**LEE'S SUMMIT**  
MISSOURI  
Development Services Department

## Development Services Staff Report

<b>File Number</b>	PL2023-069
<b>File Name</b>	PRELIMINARY DEVELOPMENT PLAN – Dental Depot
<b>Applicant</b>	Ashmore Investments, LLC
<b>Property Address</b>	1501 NE Rice Rd
<b>Planning Commission Date Heard by</b>	May 25, 2023 Planning Commission and City Council
<b>Analyst</b>	C. Shannon McGuire, Planner
<b>Checked By</b>	Sue Pyles, PE, Development Engineering Manager Aimee Nassif, AICP, Deputy Director of Development Services

Figure 2 - Elevation of the decorative water tower

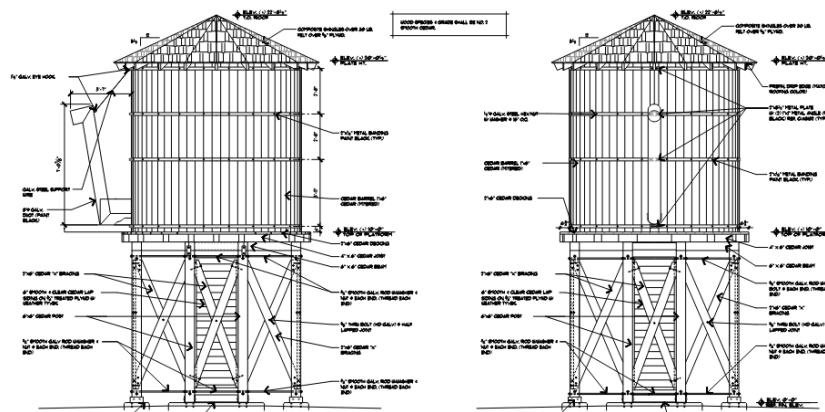
- Proposed – The applicant has proposed the use of cedar wood siding as the main material for the proposed water tower element as well as various cedar trim and accent elements on the subject building.
- Required – Wood may be only used to provide compatibility to surrounding buildings or residential districts.
- Staff Recommendation –The applicant has stated the maintenance program for Dental Depot is to revisit the property every two years. During this revisit the cedar will be inspected and repairs will be conducted as needed. These repairs may include power washing, stripping of old stain, remediating organic growth and re-staining. The applicant has committed to maintaining the property in good condition and Staff is supportive of this request.

3. The use of cedar wood siding as the main material for the proposed water tower element as well as various cedar trim and accent elements on the subject building shall be approved as a conditional material in accordance with the building elevations dated April 10, 2023 and April 21, 2023.

5. No signage or lights shall be located on the water tower located at the southwest corner of the subject site.

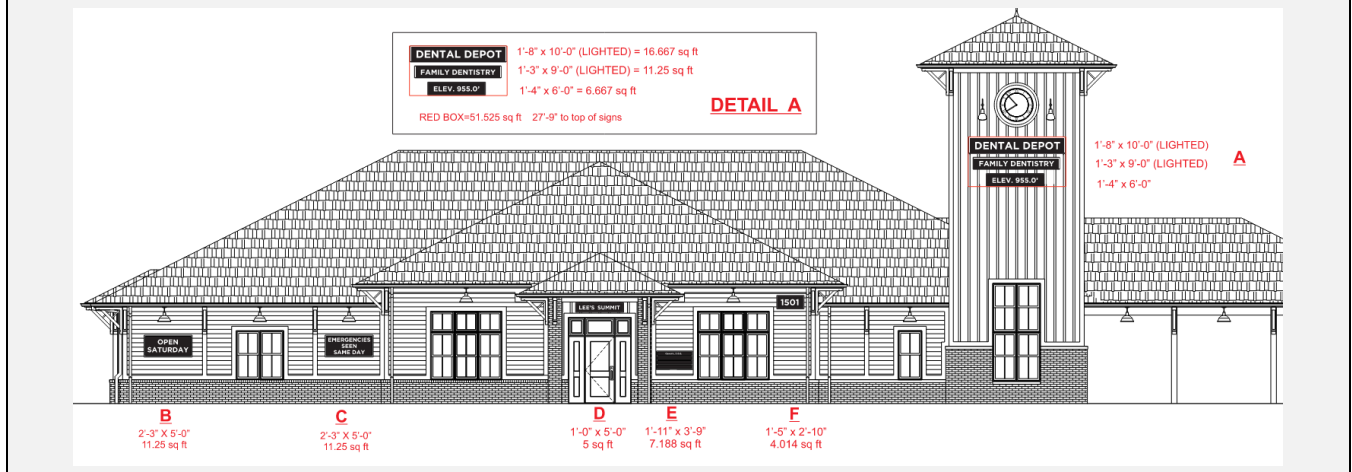
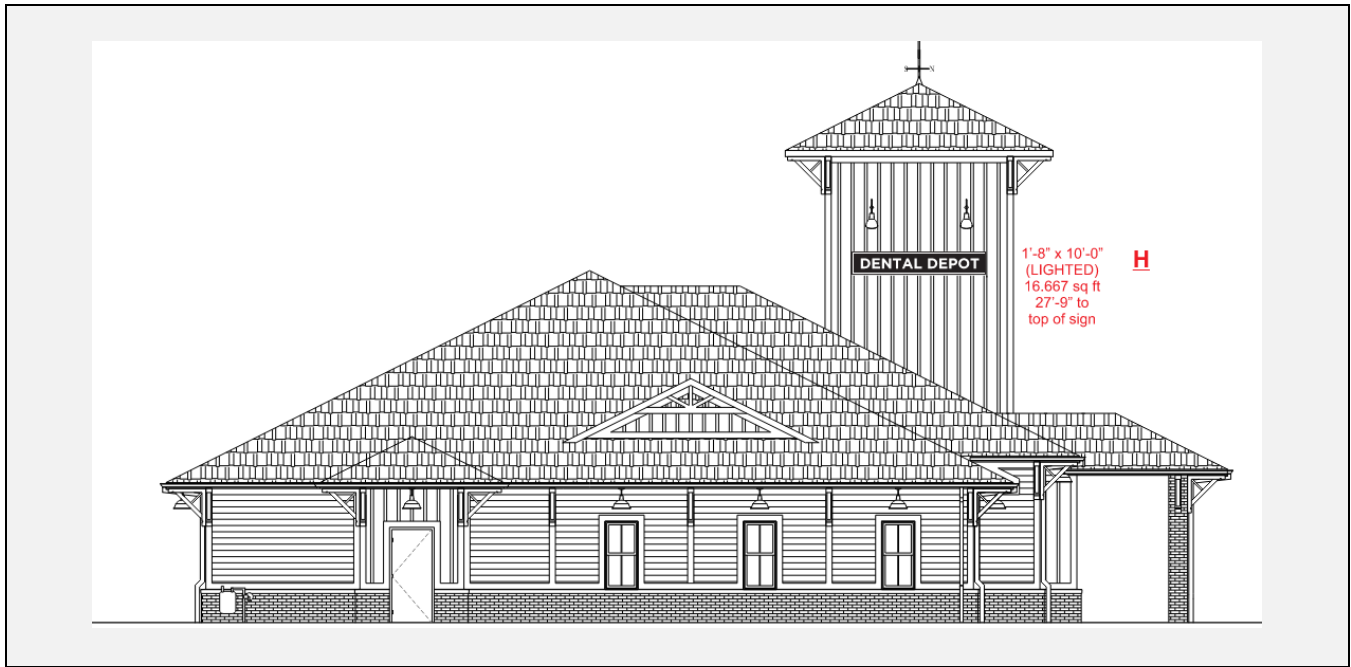
- **Recommendation** – The applicant has proposed identical wall signs (identified as sign #A, #G, & #H below) on the north, south and west elevations of the tower element of the primary building. Additionally, the wall signs identified as sign as #B, #C and a portion of the monument sign convey the same messages. When looking towards the site from the MO 291/Rice Rd corridors 7 of the 8 proposed signs will be visible at any given time. There are no grade changes, deep setbacks, or other visibility issues that Staff has found. For these reasons, staff is not supportive of the requested number of signs. Staff is supportive of a modification for additional signage but not at the extent requested. Instead, Staff recommends the wall signs identified as #B, #C and #H be removed from

the proposed sign package and all other requested signs be permitted It is also important to note that there will not be any signage located on the freestanding water tower structure.

West Elevation					
	Copy	Letter Height	Sign Area	Number of Signs	Lighting
<b>Wall Sign #A</b>		9"	117 sq. ft. (10% of façade area)	--	Internal lighting
<b>Wall Sign #B*</b>		6"	11.25 sq. ft. (4% of façade area)	--	No lighting proposed
<b>Wall Sign #C*</b>		4"	11.25 sq. ft. (4% of façade area)	--	No lighting proposed

<p><b>Wall Sign #D</b></p> 	<p>6"</p>	<p>5 sq. ft. (0.9% of façade area)</p>	<p>--</p>	<p>No lighting proposed</p>
<p><b>Wall Sign #E</b></p> 	<p>1"</p>	<p>7.2 sq. ft. (1.0% of façade area)</p>	<p>--</p>	<p>No lighting proposed</p>
<p><b>Wall Sign #F</b></p> 	<p>3.75"</p>	<p>4 sq. ft. (0.8% of façade area)</p>	<p>--</p>	<p>No lighting proposed</p>

\*Not staff supported

2. A modification to the maximum of three (3) wall signs shall be granted to allow five (5) wall signs identified as signs #A, #D, #E, #F and #G on the sign specification sheets submitted and uploaded on April 25, 2023.

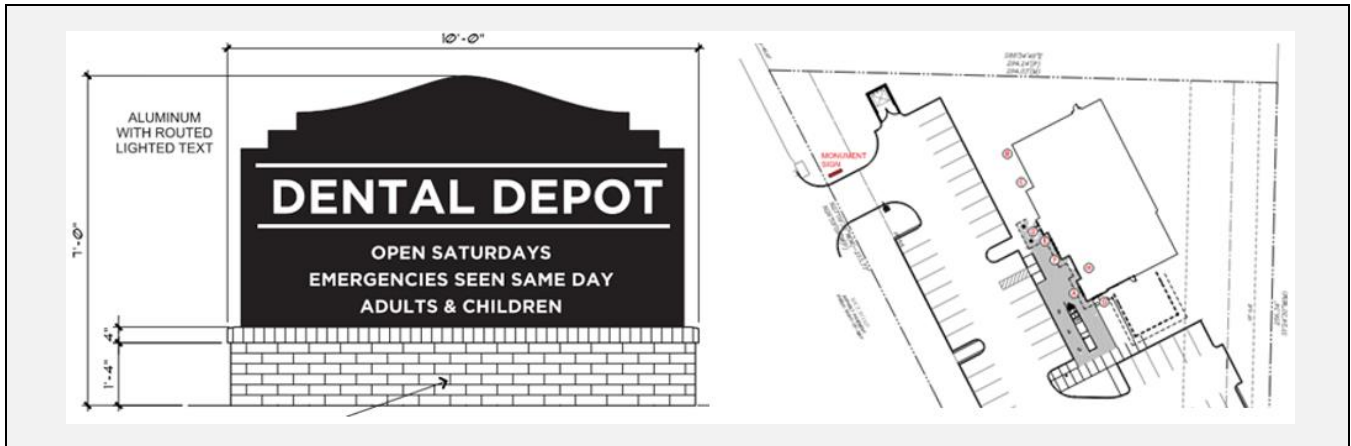
South Elevation					
	Copy	Letter Height	Sign Area	Number of Signs	Lighting
<p><b>Wall Sign #G*</b></p> 		<p>9"</p>	<p>16.7 sq. ft. (3.7% of façade area)</p>	<p>--</p>	<p>Internal lighting</p>

\*Not staff supported

South Elevation					
	Copy	Letter Height	Sign Area	Number of Signs	Lighting
Wall Sign #H*		9"	16.7 sq. ft. (7.8% of façade area)	--	Internal lighting

\*Not supported by staff
